# THE SHOP'S AT MERIDIAN RANCH

FILING NO. 1, LOT 4

PHOTOMETRIC PLAN

**Shop's @ Meridian Ranch**  
Site Development Plan  
Meridian Road  
Falcon, CO

DRAWING NO. **4**  
PHOTOMETRIC PLAN

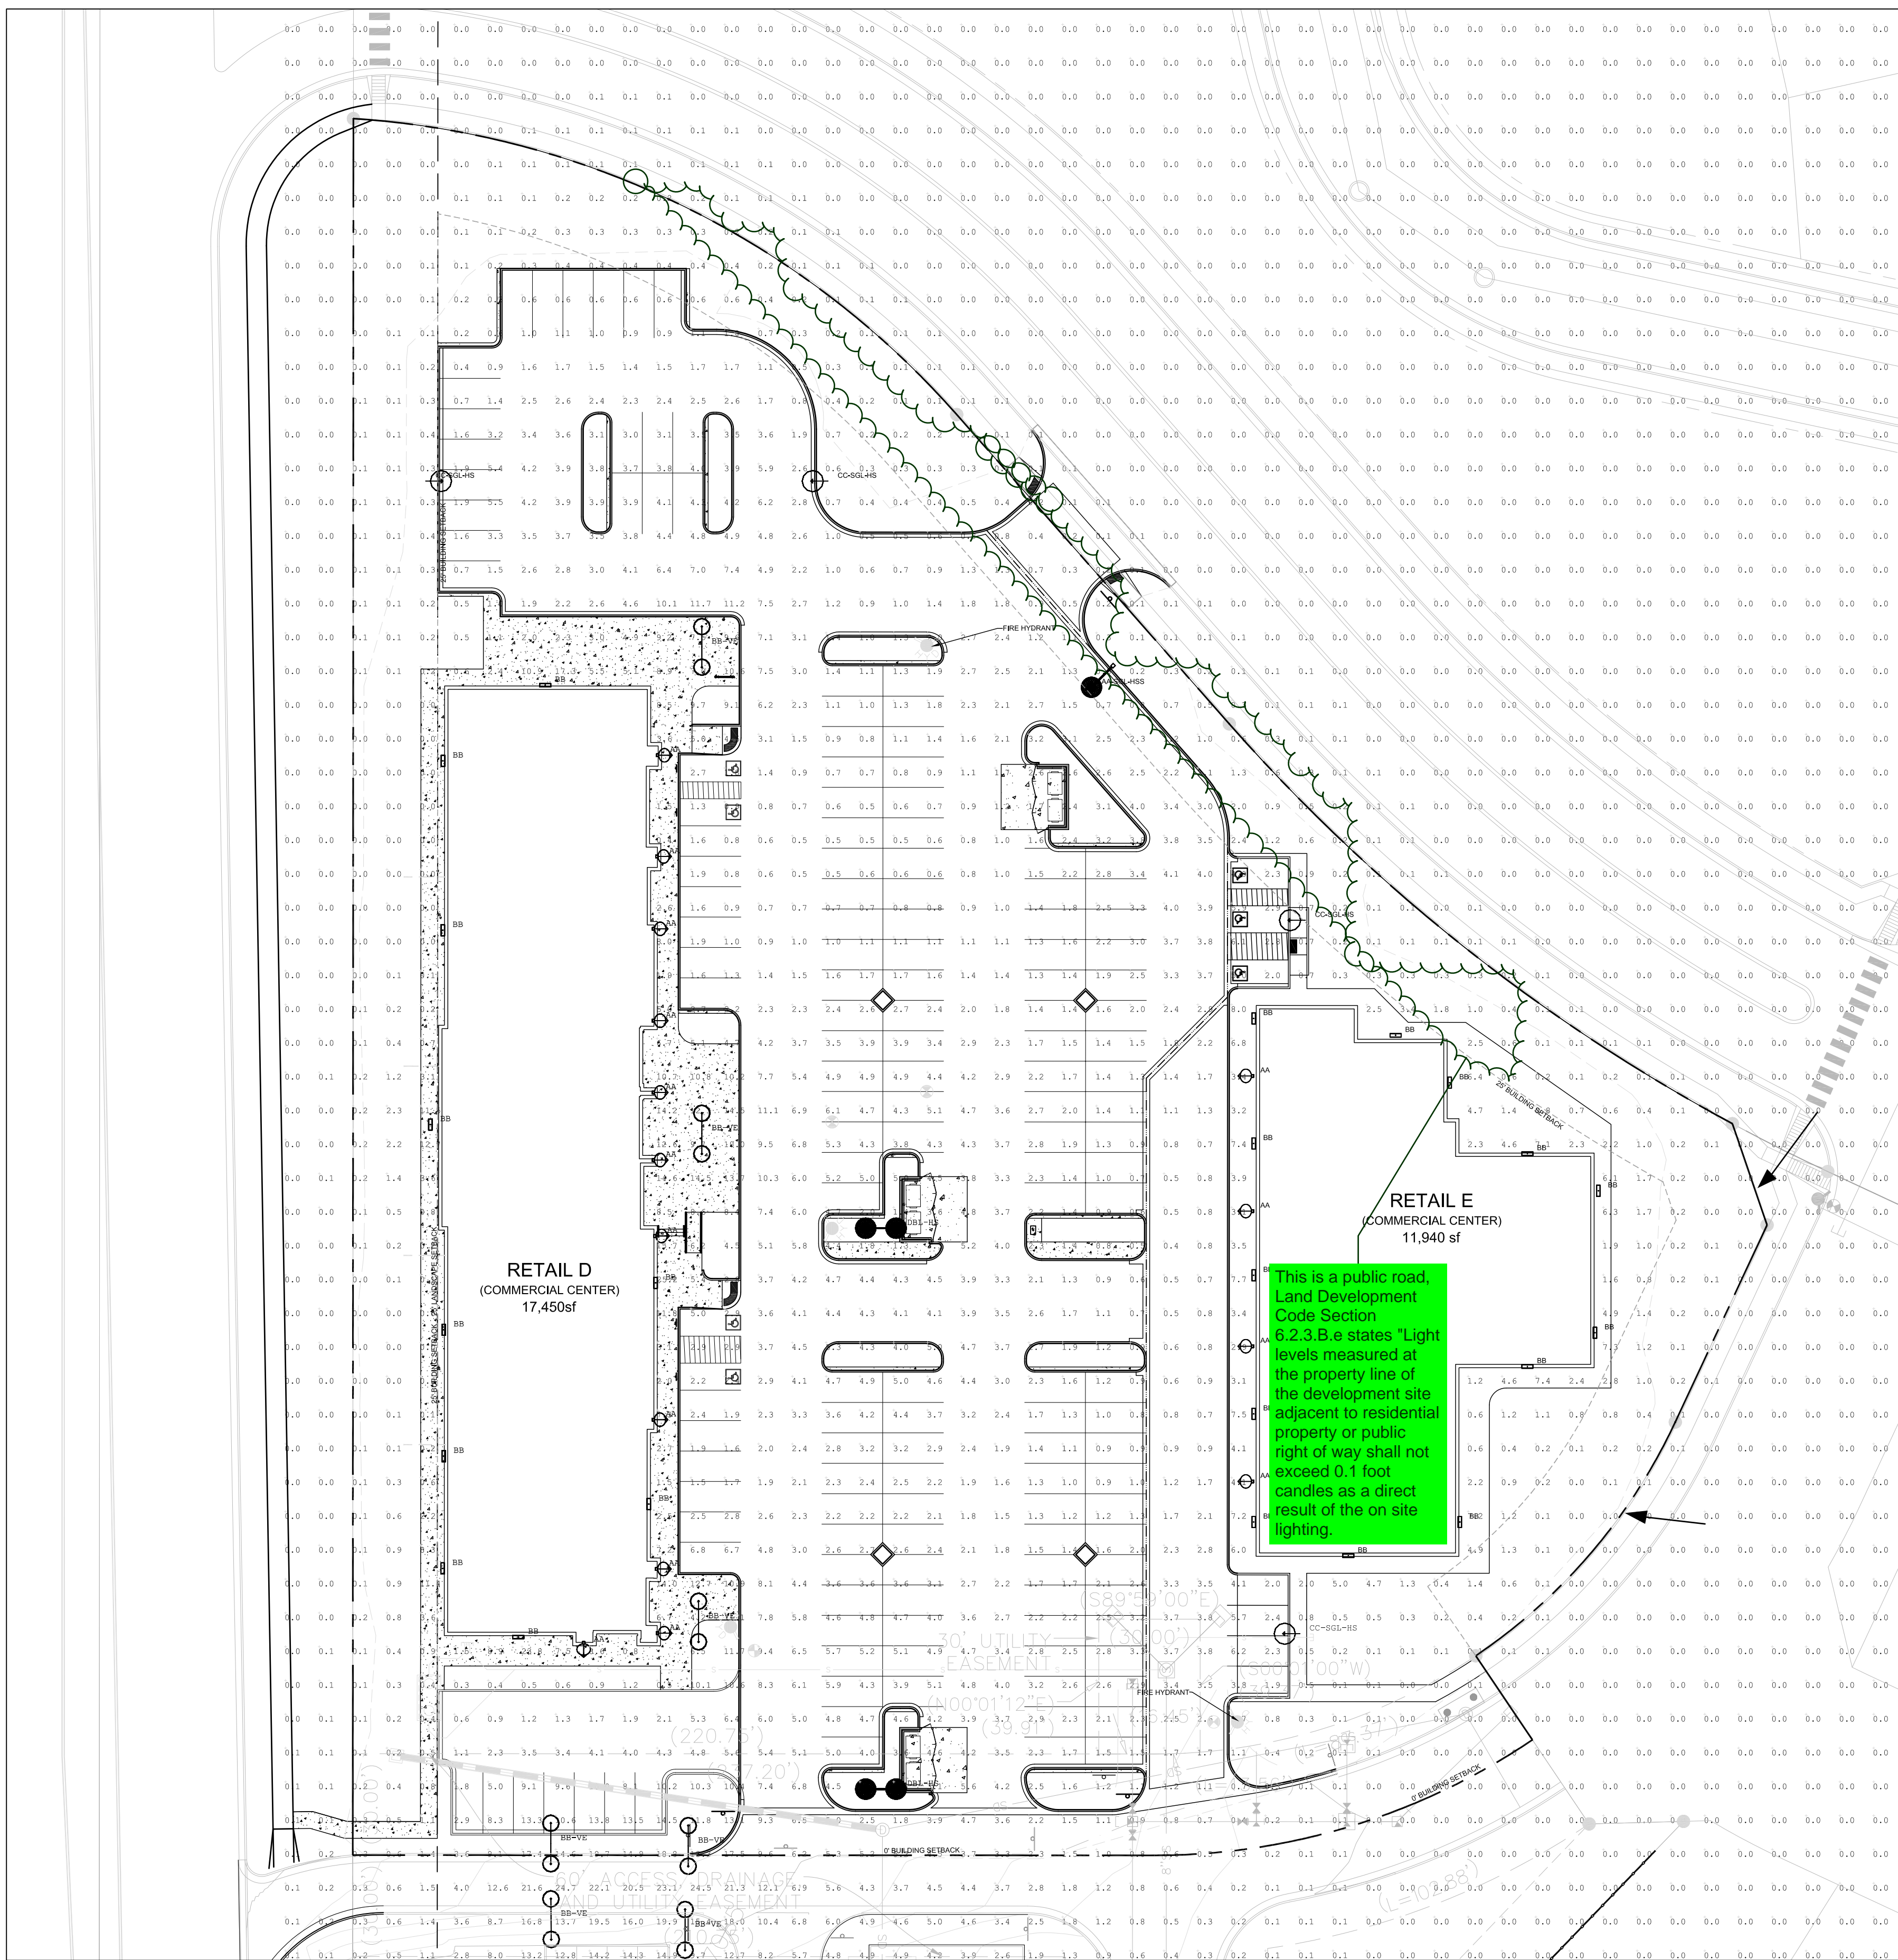
This is a public road, Land Development Code Section 6.2.3.B.e states "Light levels measured at the property line of the development site adjacent to residential property or public right of way shall not exceed 0.1 foot candles as a direct result of the on site lighting."
